# PlanGrid Task Report - Feb 14, 2024

L04916\_Princeton Woods FSU (Dumfries, VA)

3350 Pine Bluff Drive, Dumfries, Virginia

## #123 [CNTL 098] Ansul pull labeling.

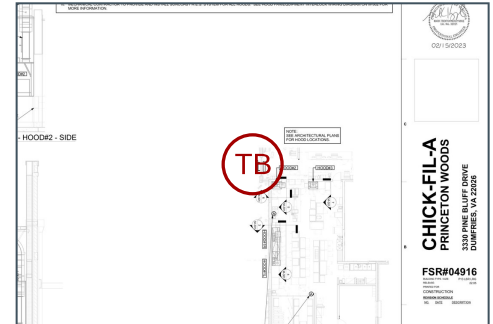
Label all Ansul pull stations  
for which hoods they serve.

## #122 [CNTL 107] (MISC) Missing Ansul pull stations

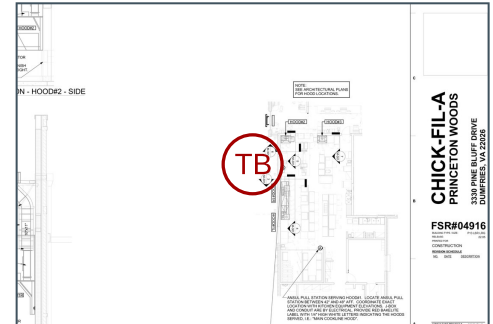
Ansul pull stations are not yet installed at locations designated

# #121 [CNTL 107] (MISC) Zone Damper Thermostats do not have power

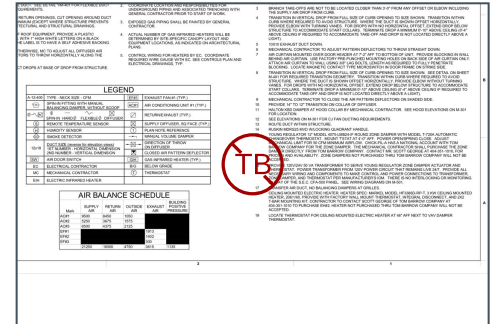
Description  
Thermostat controlling zone dampers need transformer installed in order to power thermostats

# #120 [EXHA 127] Grease exhaust duct is not supported.

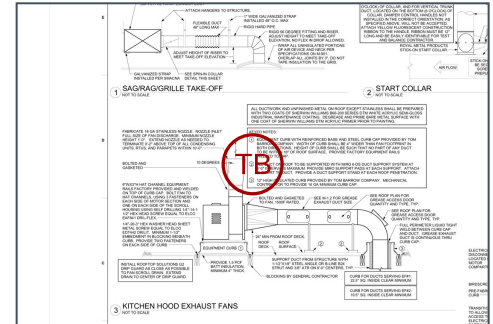
Exhaust duct for EF#1 is to be supported per kitchen hood exhaust fan detail on 6'0" centers.

## #119 [UNIT 152] Trane equipment missing field kits.

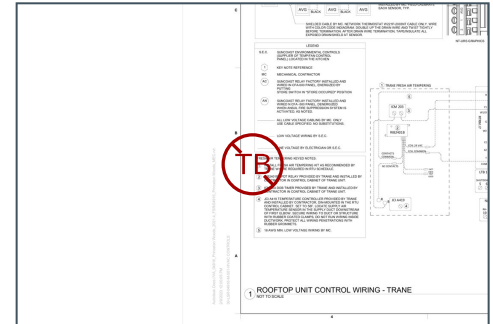
Trane equipment does not have additional manufacturer supplied, field installed relays, delay timer, or discharge temperature controller with FAT scheduled in design.

# #118 [UNIT 168] Equipment not secured properly.

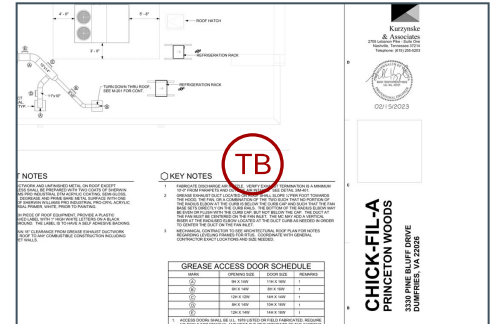
Equipment not secured properly to curb, high wind/ seismic clips not installed. Mechanical stated that unit package did not come with seismic clips.
